SUNDRY NOTICES AND REPORTS ON WELLS
Do not use this form for proposals to drill or to re-enter an abandoned well. Use form 3160-3 (APD) for such proposals.

8. Well Name and No.
LIMESTONE 11 23 33 FEDERAL 1H

CHEVRON RESPECTFULLY REQUESTS TO CHANGE PLANS FOR BOP TESTING DUE TO THE UTILIZATION OF THE GE/VETCO SH-2 MULTIBOWL WELLHEAD. CHEVRON REQUESTS TO NIPPLE UP AND TEST BOPE ON THE SURFACE CASING TO 5,000 PSI HIGH AND 250 PSI LOW, AND TO PERFORM SUBSEQUENT TESTS AS NEEDED, NOT TO EXCEED 21 DAYS FROM THE PREVIOUS TEST. THE FIELD REPORT FROM THE GE/VETCO REPRESENTATIVE AND THE BOP TEST INFORMATION WILL BE PROVIDED IN A SUBSEQUENT REPORT AT THE END OF THE WELL. PLEASE SEE THE ATTACHED WELLHEAD SCHEMATIC AND INSTALLATION MANUAL.

**PECOS DISTRICT
CONDITIONS OF APPROVAL**

BLOWOUT PREVENTOR SCHEMATIC

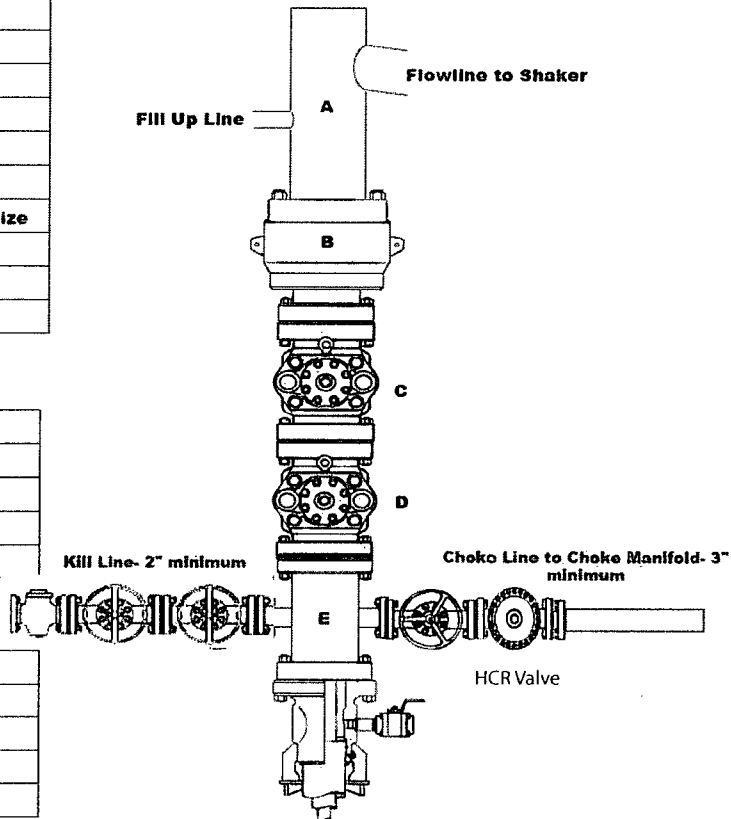
5M BOP tested to 5,000 psi

3. **Operator has proposed a multi-bowl wellhead assembly. This assembly will only be tested when installed on the surface casing. Minimum working pressure of the blowout preventer (BOP) and related equipment (BOPE) required for drilling below the surface casing shoe shall be 5000 (5M) psi.**

5M system requires an HCR valve, remote kill line and annular to match. The remote kill line is to be installed prior to testing the system and tested to stack pressure.
